MUNICIPALITY OF ANCHORAGE

DEVELOPMENT SERVICES DEPARTMENT

SUBJECT: BCA-01-2021

Synopsis:

photo-2

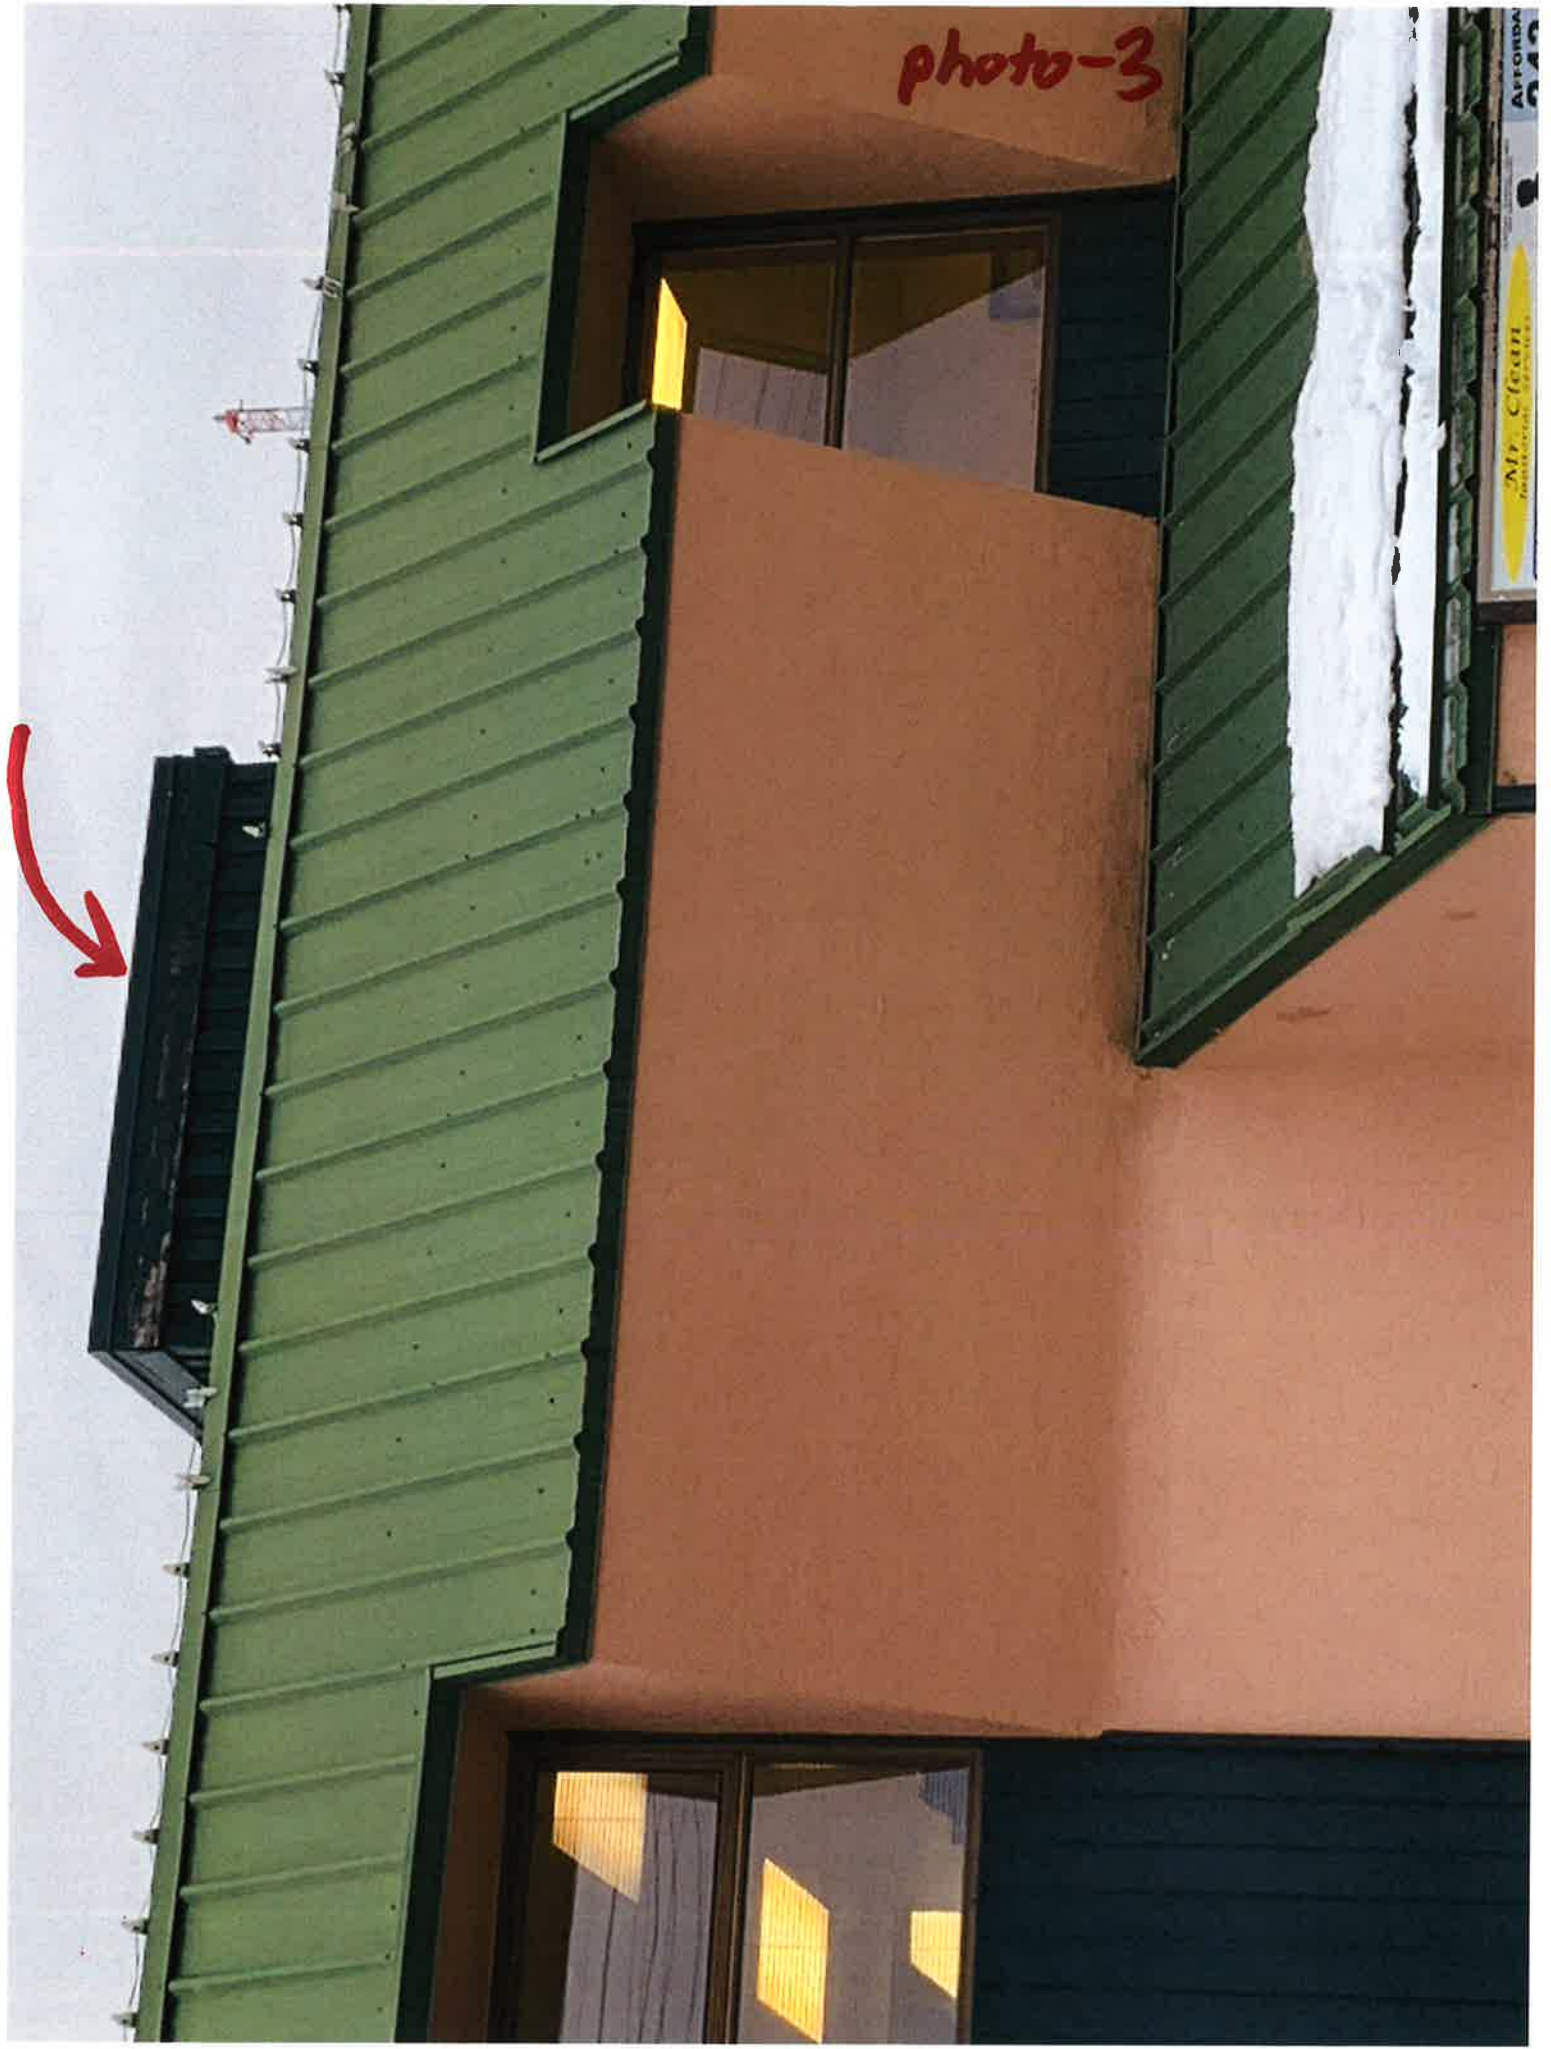
Sometimes new buildings have a roof line that only allows for less than the minimum required clearances of an elevator, so a raised area is constructed to provide for the clearances (see attached photos 2 -5 of raised areas above roofs created to provide for the clearances for safety of personnel). When new hoistways are constructed within existing buildings, it is very common to see a raised area created, or in many cases, the existing overhead structure is modified to provide for the required clearances and also maintain required structural, snow load and seismic requirements without having to create a raised area, depending on the vertical dimensions.
